Model: Kaiser1	Date: 29-Feb-00	No.: RH306001a
----------------	-----------------	----------------

Firmware history for the Kaiser1 (USA Model)

Model: Kaiser1		Date: 29-Feb-00	No.: RH306002
Subject: Note on the PIF's grounding plate attachment		Prepared by: M. Mano	
From: Technical Services Dept., GTS Division			
Classification:	<input type="checkbox"/> Troubleshooting	<input type="checkbox"/> Part information	<input type="checkbox"/> Action required
	<input checked="" type="checkbox"/> Mechanical	<input type="checkbox"/> Electrical	<input type="checkbox"/> Service manual revision
	<input type="checkbox"/> Paper path	<input type="checkbox"/> Transmit/receive	<input type="checkbox"/> Retrofit information
	<input type="checkbox"/> Other ( )

[Fig. 2]

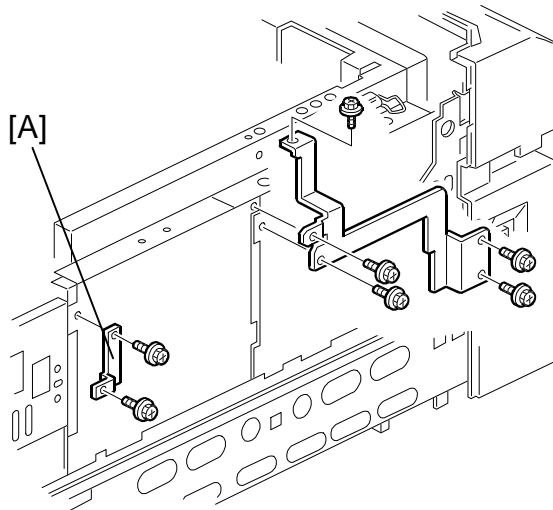
The PIF option grounding plate [A] (P/N: H3064662) in the following 15 units will bend slightly when you attach it, as shown in figure 2.

However, the plate will function normally and the slight bending will not affect the operations of the printer unit or mainframe in any way.

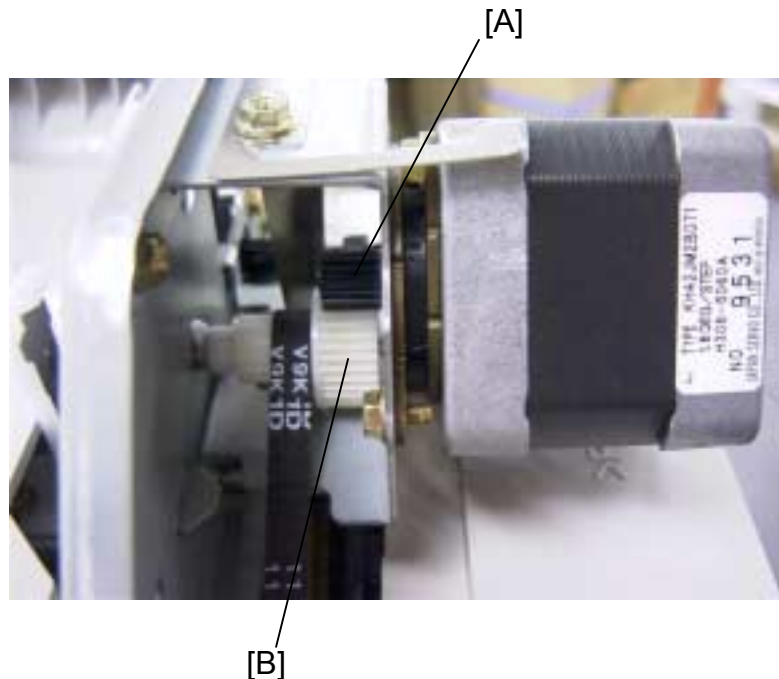
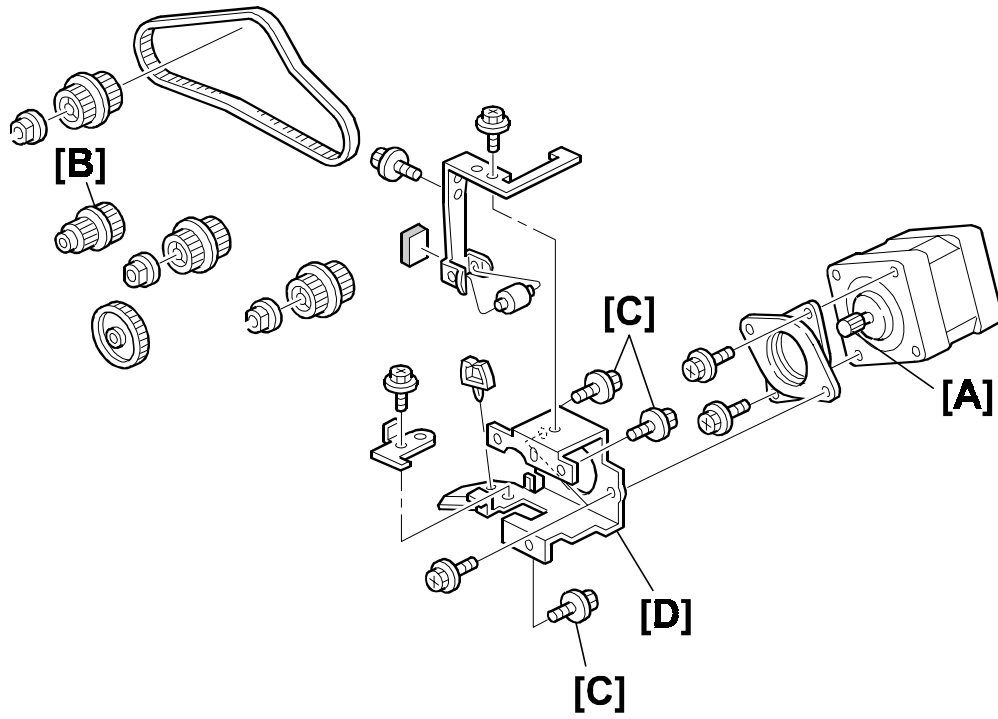
A squeaking sound can be heard coming from the ADF unit.

Vibration of the ADF motor gear [A] and ADF rear slow down gear [B] as shown below.

In the field, please re-tighten the 3 screws [C] (see the next page) that secure the ADF motor bracket [D] to the ADF unit. This will ensure that the 2 gear shafts are parallel.

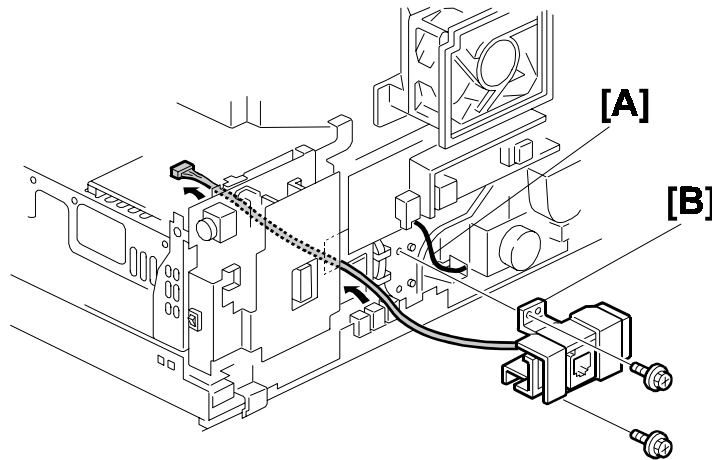
When the following option(s) are installed, the paper end sensor harness [A] may be pinched between the mainframe and the bracket [B].

If the harness [A] is pinched, a number of symptoms can occur such as:

When installing the bracket for the options mentioned above, please make sure that the harness remains to the right of the bracket and does not get pinched.

For the N. America model, the routing of the harness has been changed from the beginning of March 2000 production.

H1101601.WMF

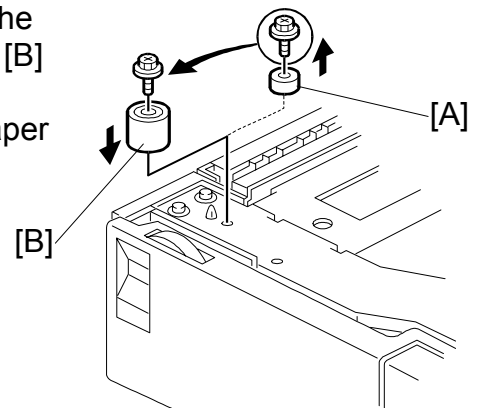
A note has been added to step 1 of the PFU installation procedure.

1. When the paper feed unit is installed just under the machine, change the small leg [A] to the big one [B] that is enclosed.

**NOTE:** Remove the 2 tie-wraps securing the paper feed rollers (located under the red tag).
